# Imperial Valley College

## Americans with Disabilities Act Facilities Evaluation

# Americans with Disabilities Act Facilities Evaluation

SHEET 6

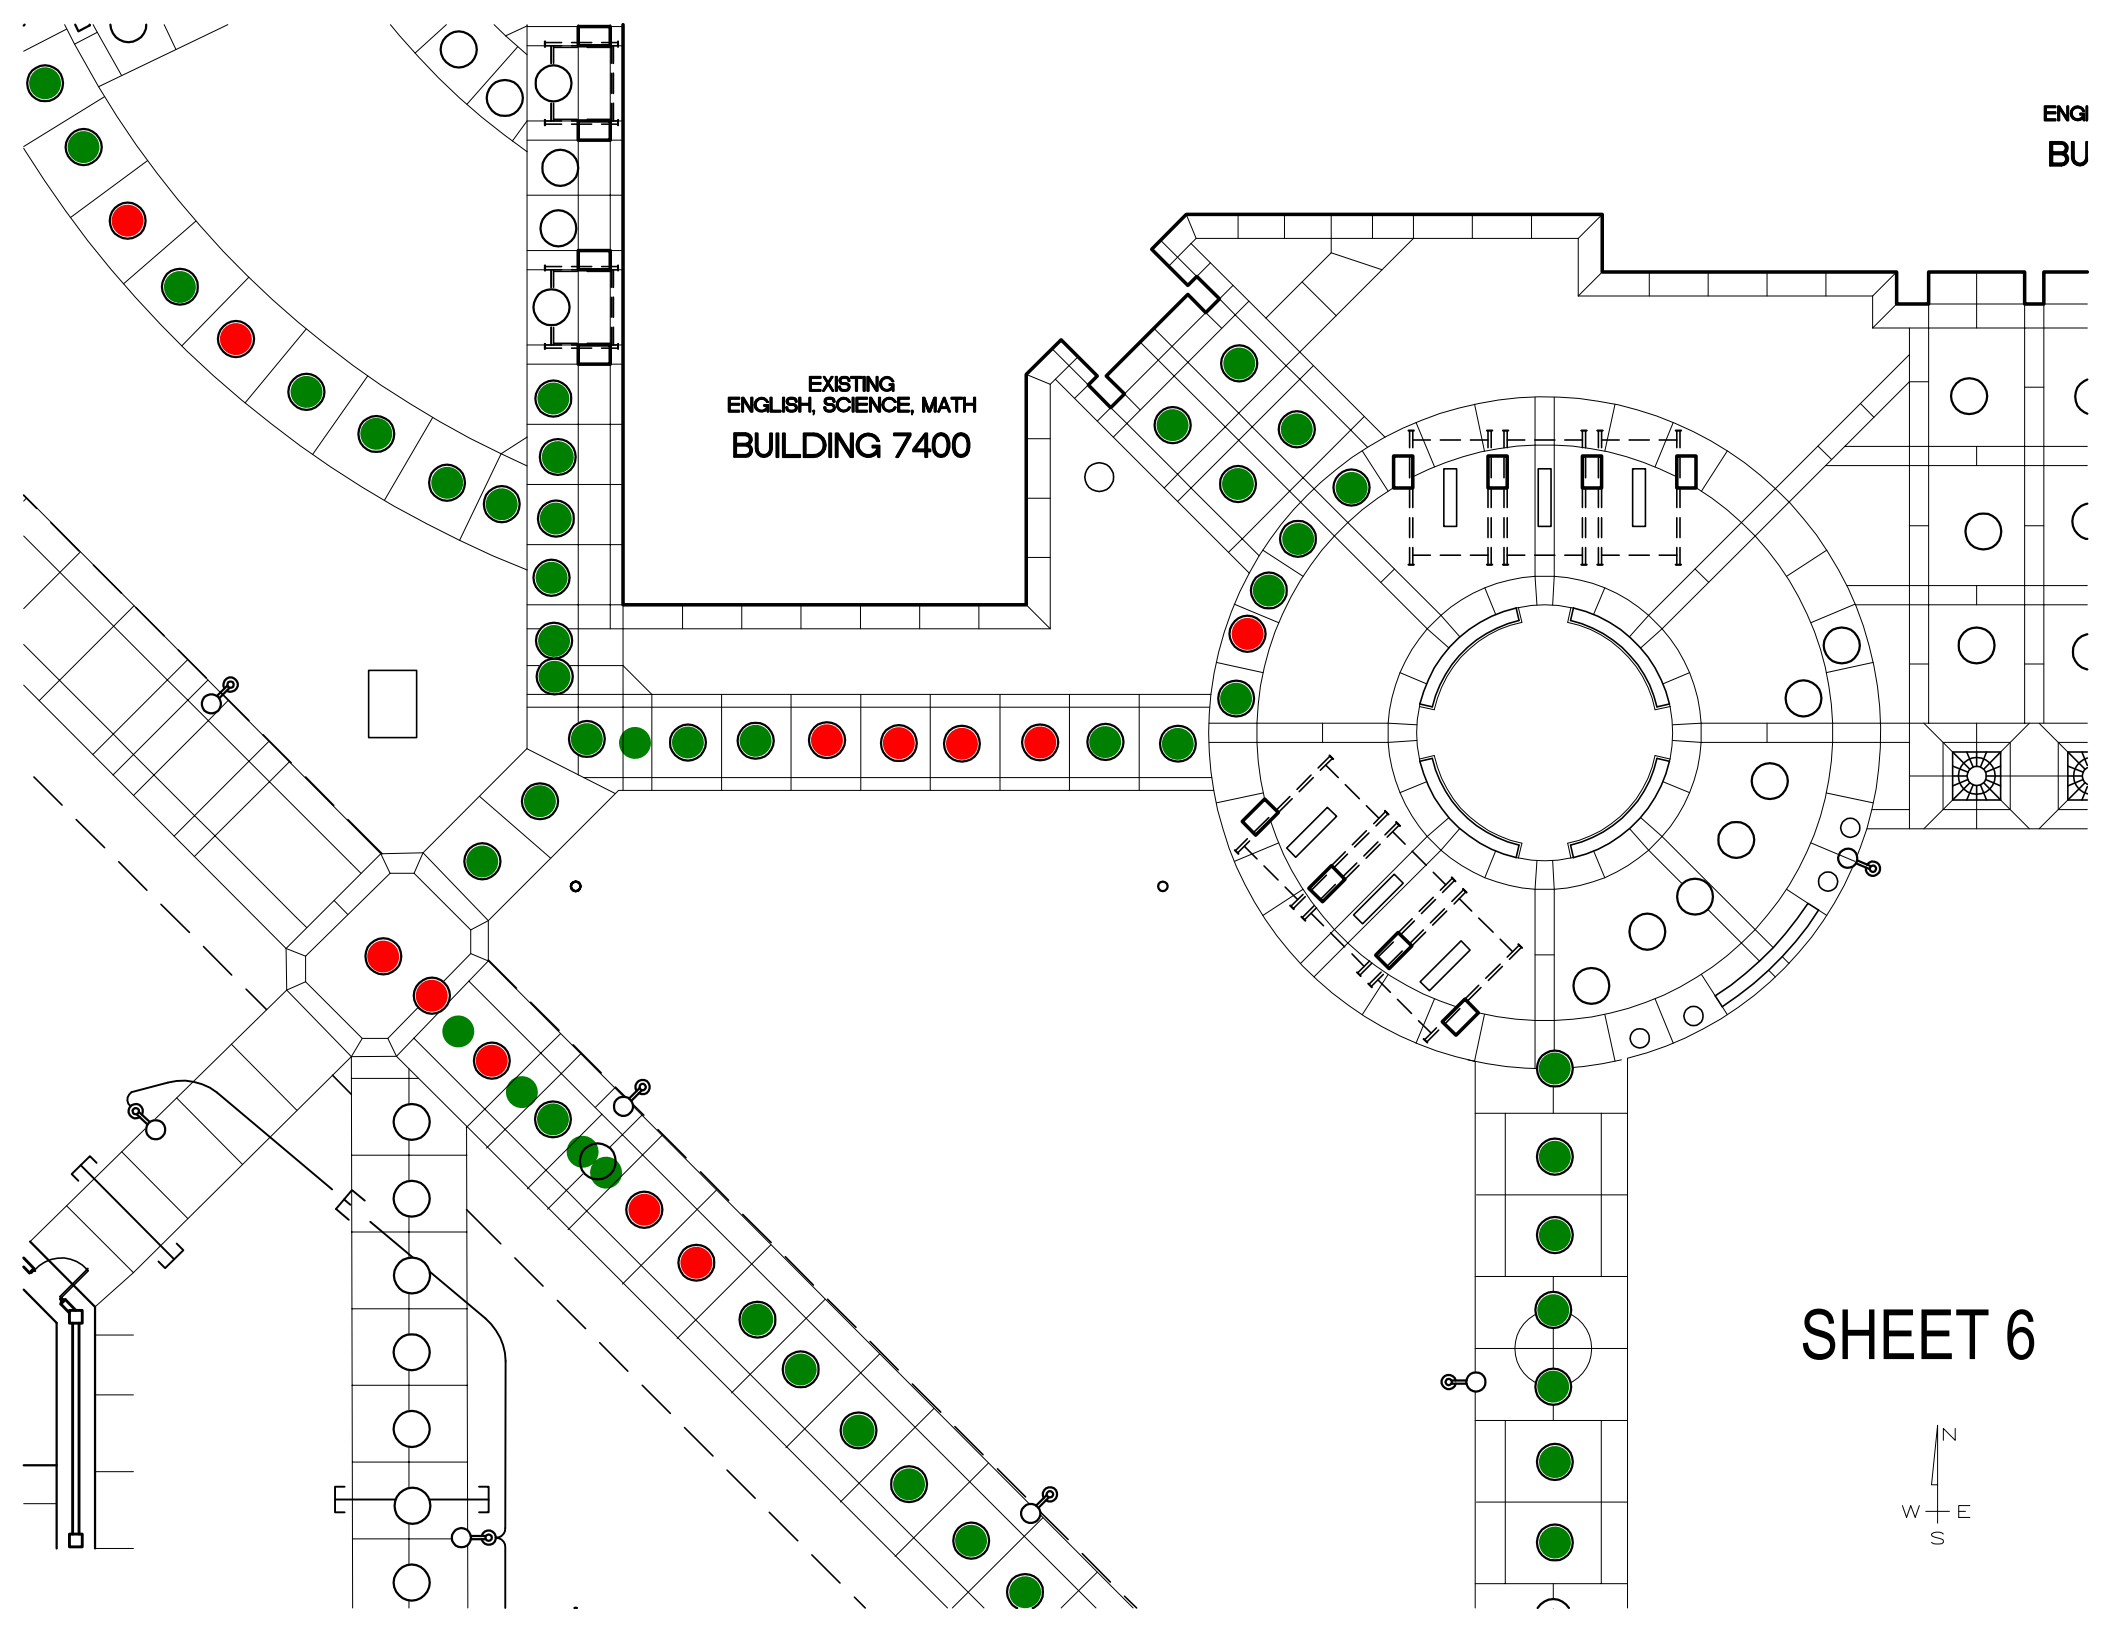
- Sheet 5: A couple of gaps between concrete slabs, minor cracks.
  - Sheet 6: Some large gaps and minor cracking in expansion joints, some sections of sidewalk with bad slope, multiple cracked small concrete slabs.

SHEET 32

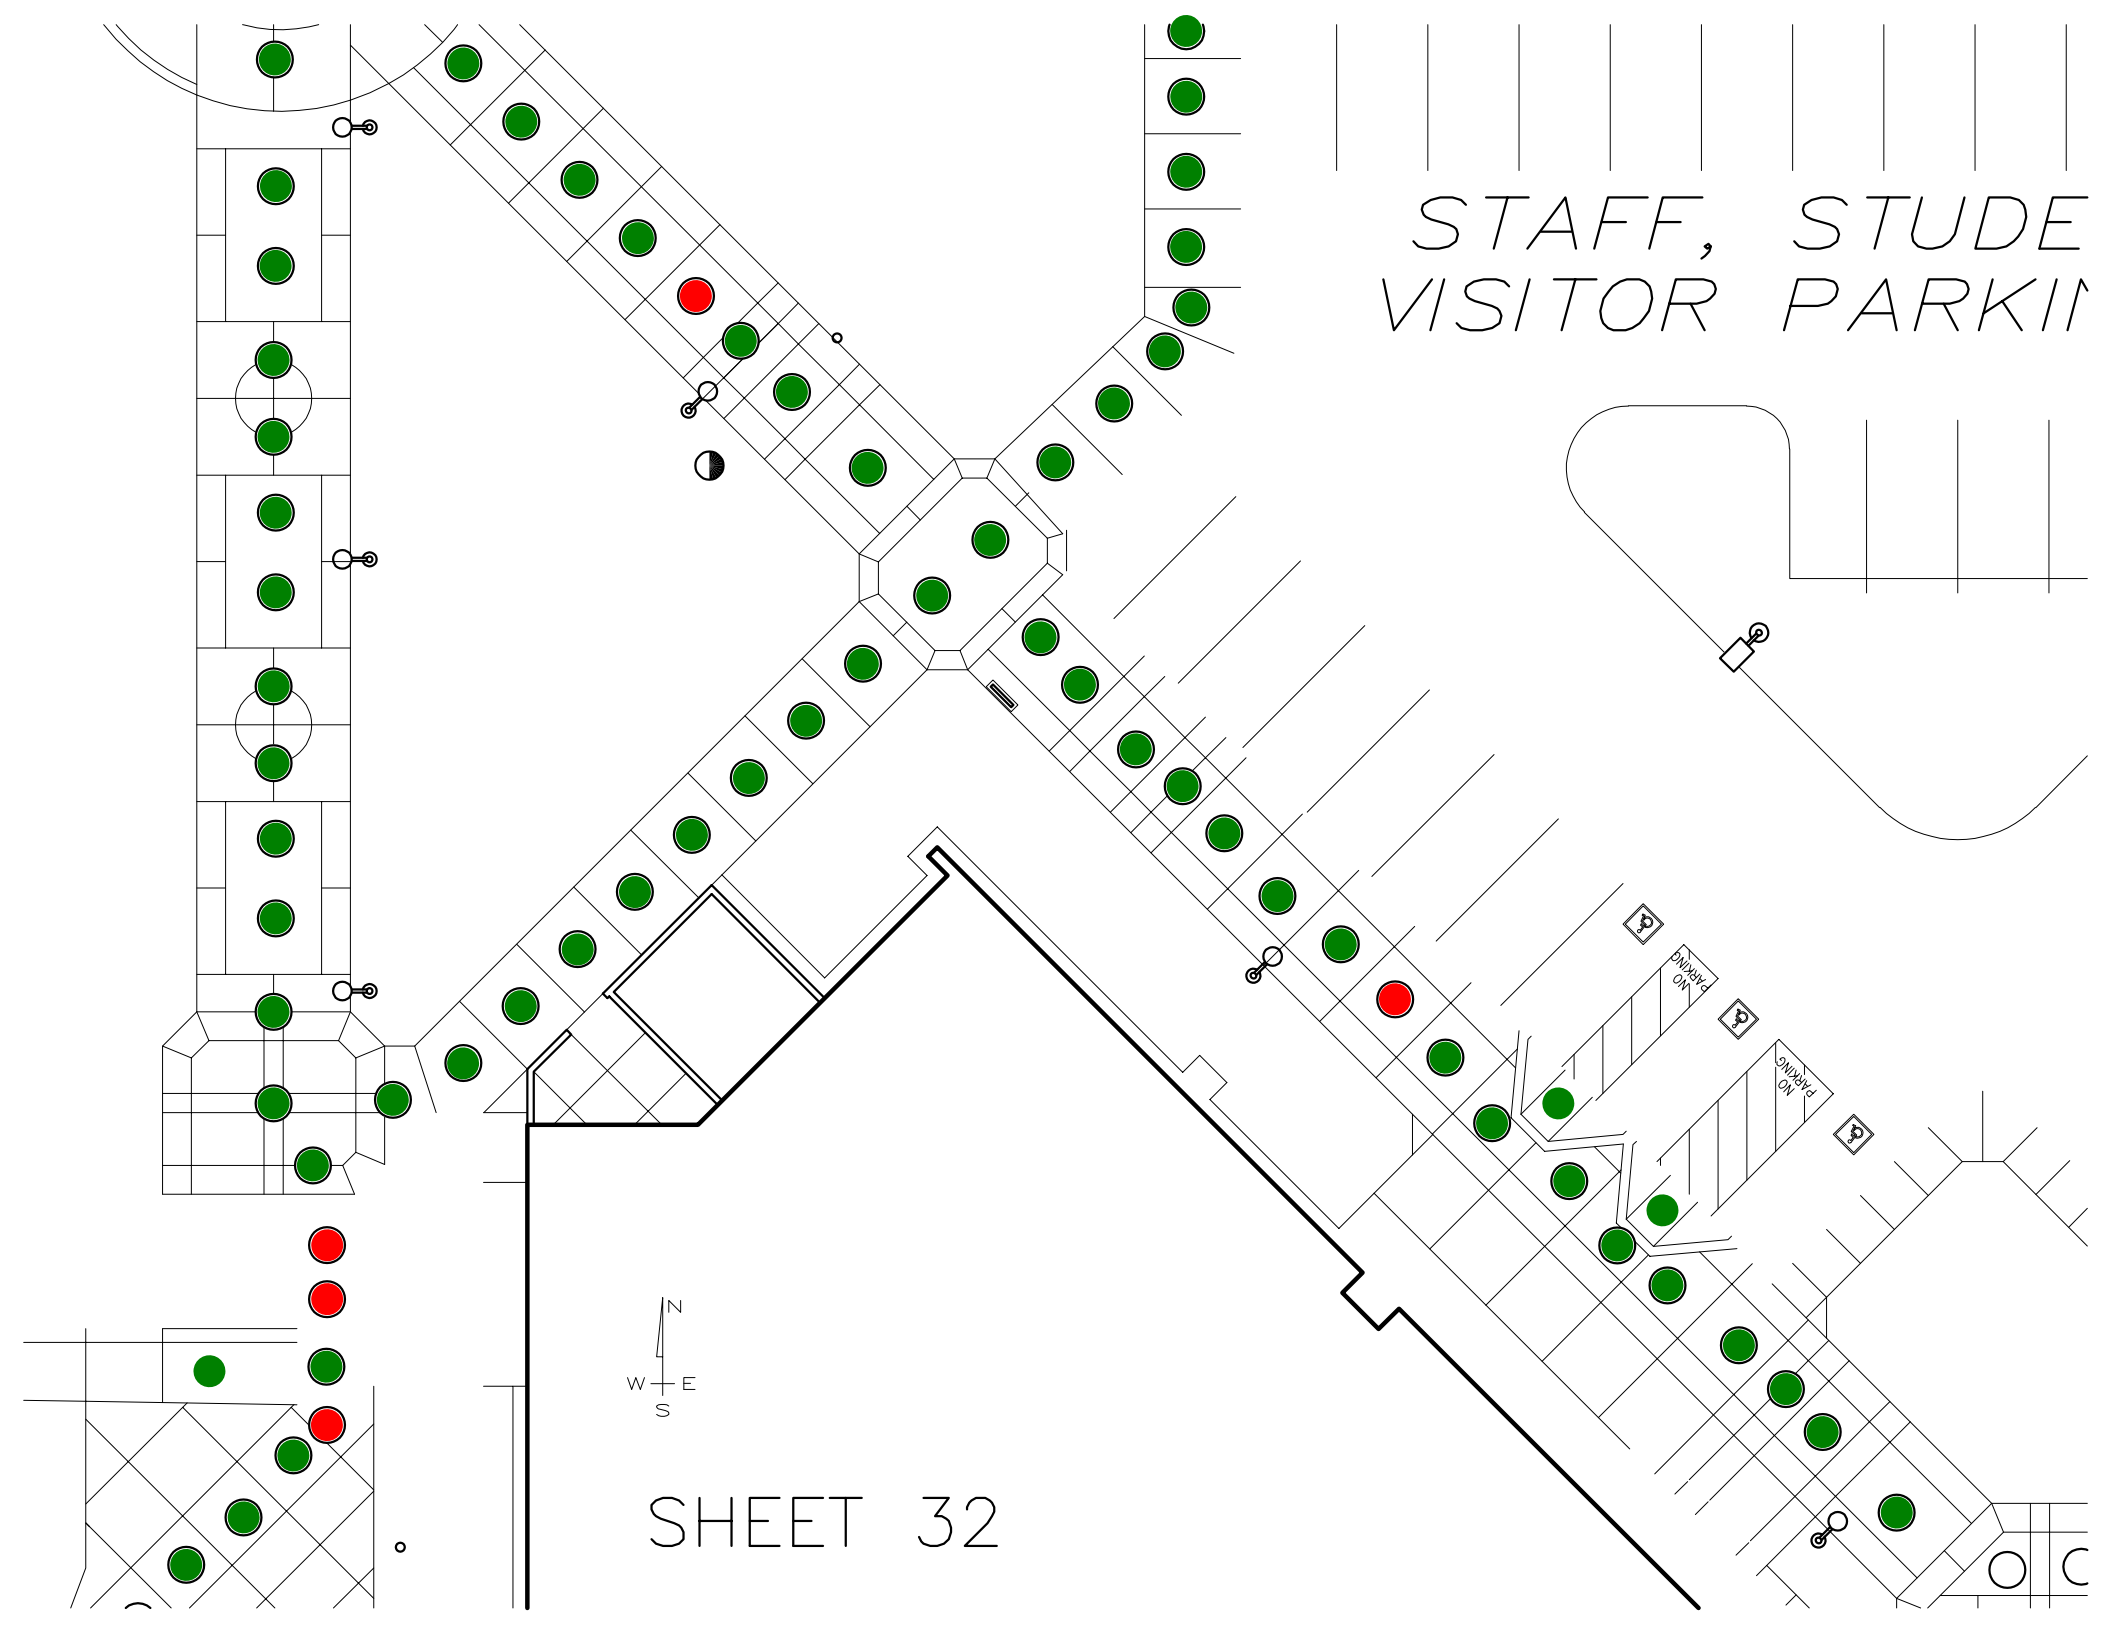
- Sheet 32: Three accessible parking signs located within the path of travel that are less than 80 inches from the floor,

reducing head clearance along the sidewalk. Two curb ramps with cracks, some sections of sidewalk with cracks across and changes in elevation at or greater than half an inch, large gaps in between some expansion joints, and a couple of sections with bad slope.

**Sheet 32** – Three accessible parking signs obstruct the pedestrian path due to low clearance ( $< 80"$ ).

2. **Repair & Replace Damaged Surfaces:** Concrete pathways with significant cracks, holes, or vertical displacement should be ground down, filled, or replaced.
3. **Reconstruct or Retrofit Ramps and Handrails:** Any ramps, including accessible curb ramps, exceeding slope tolerances, missing appropriate handrails, or lacking smooth transitions should be revised.
4. **Correct Expansion Joints:** Damaged or missing filler in joints should be addressed to eliminate tripping hazards and changes in level.
5. **Improve Signage and Markings:** Revise height of accessible parking signage on the path of travel, and repaint parking markings.

# SHEET 53

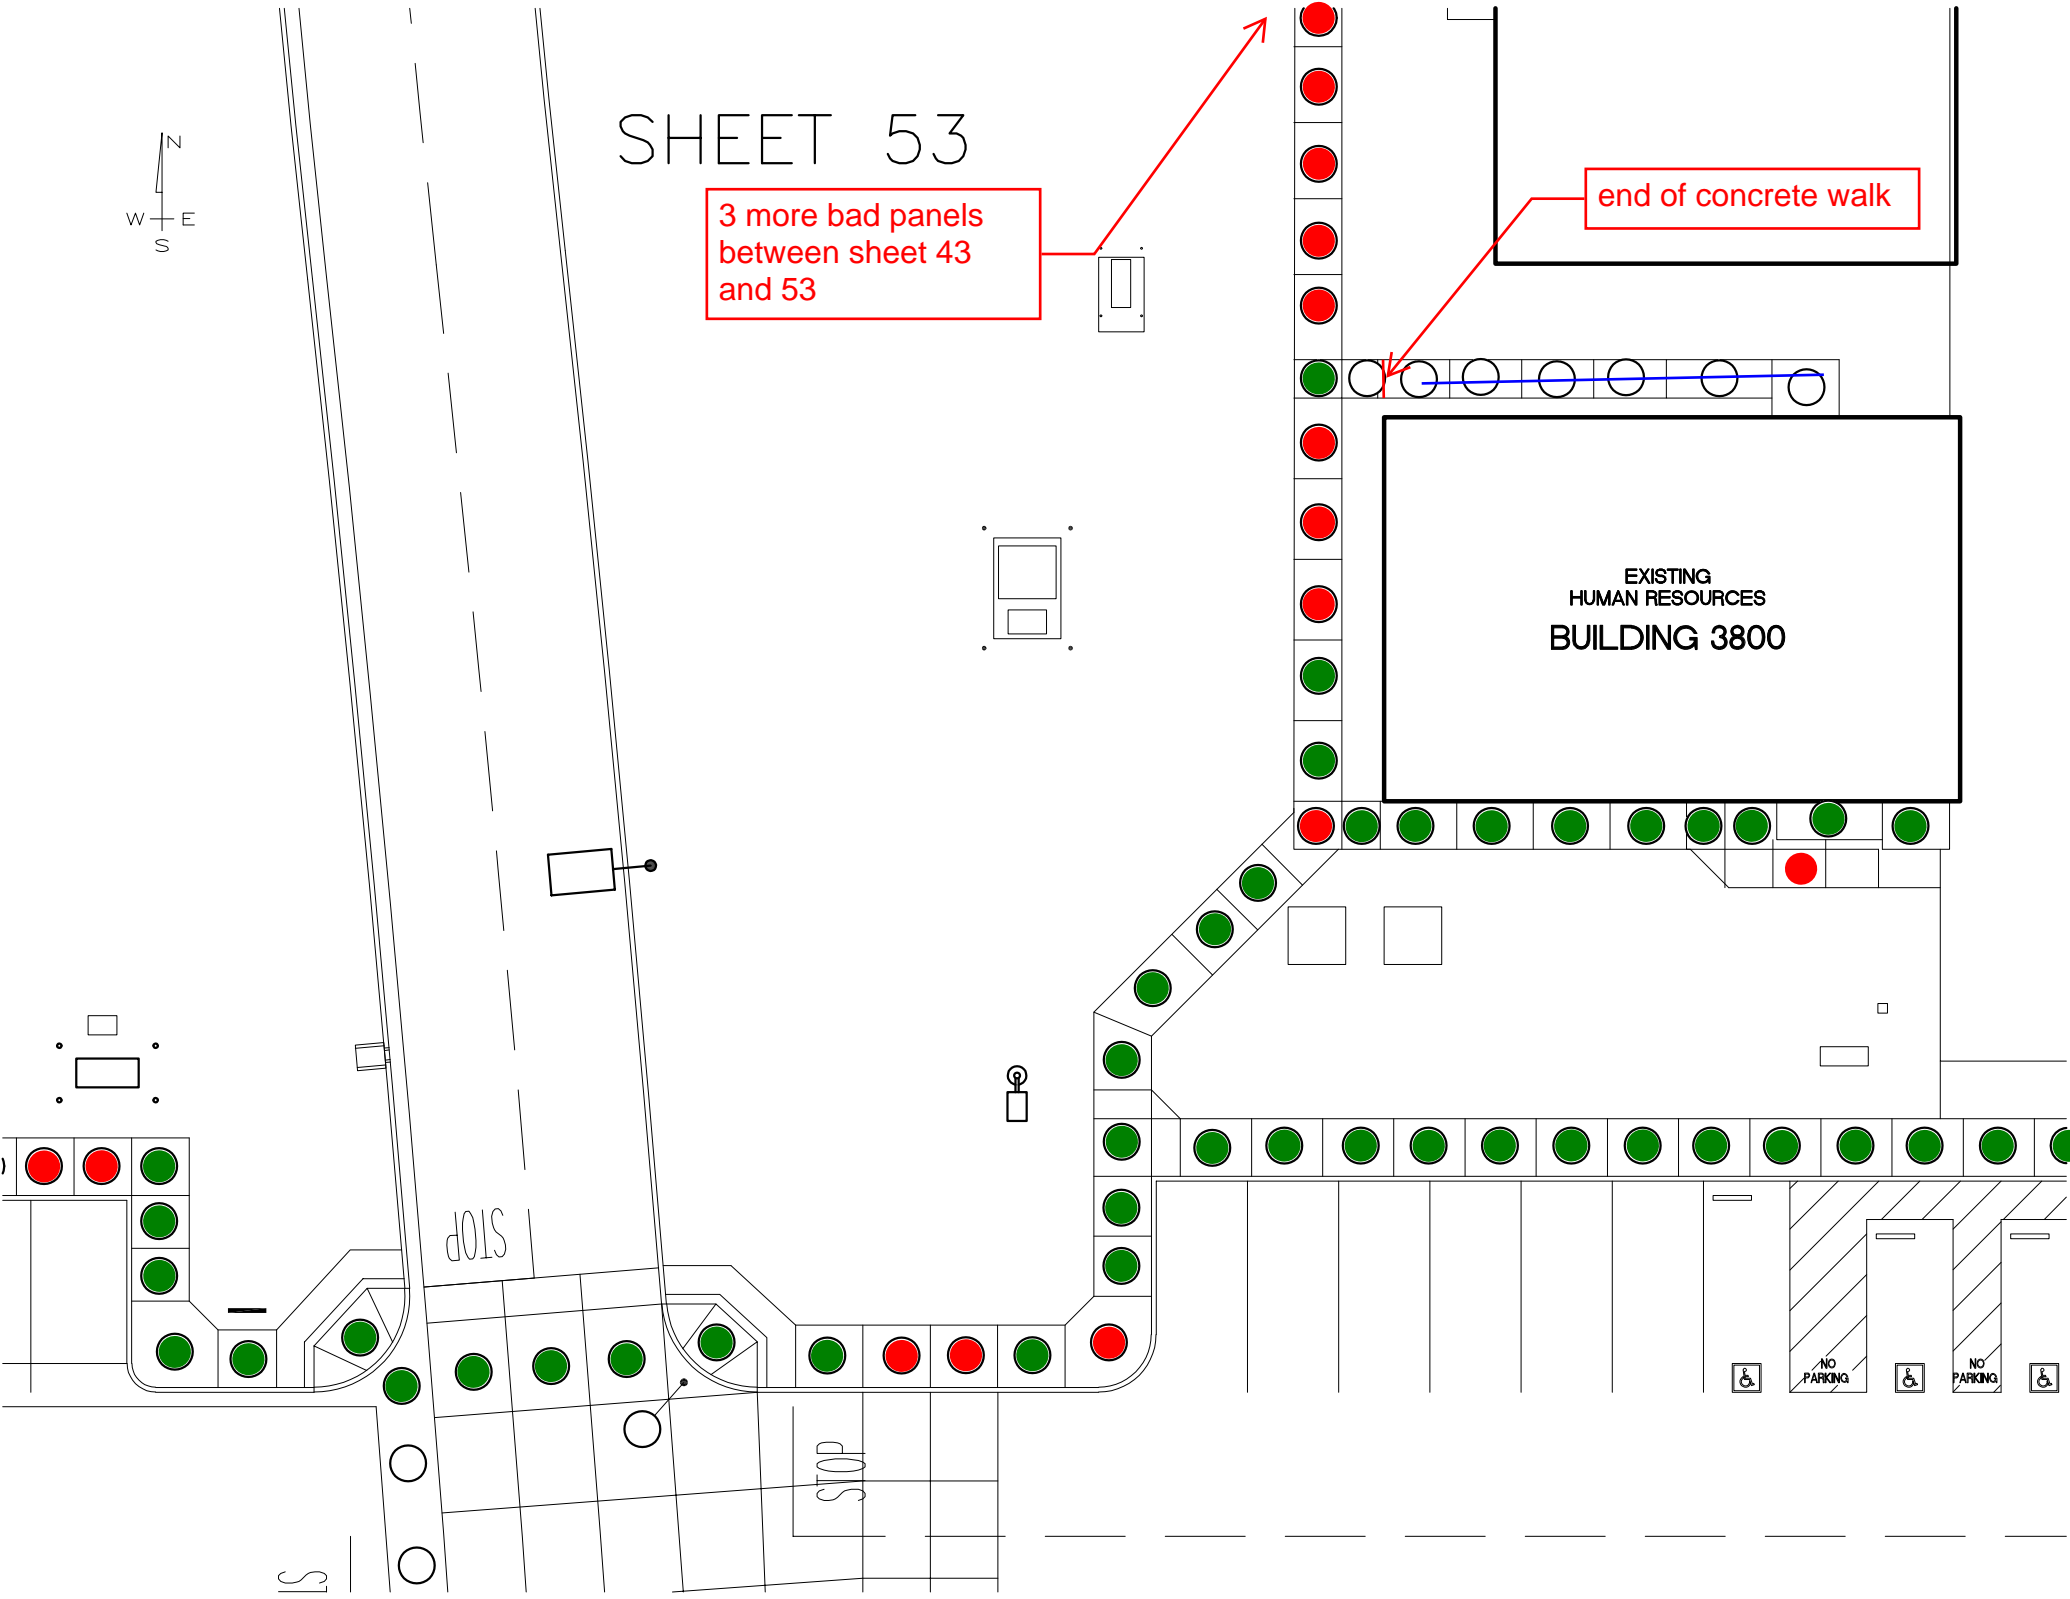
- Sheet 53: Various instances of cracking across the sidewalk, expansion joints with wear and significant gaping, lifting of sidewalk sections, multiple stretches of sidewalk with bad slope reaching north into sheet 43.
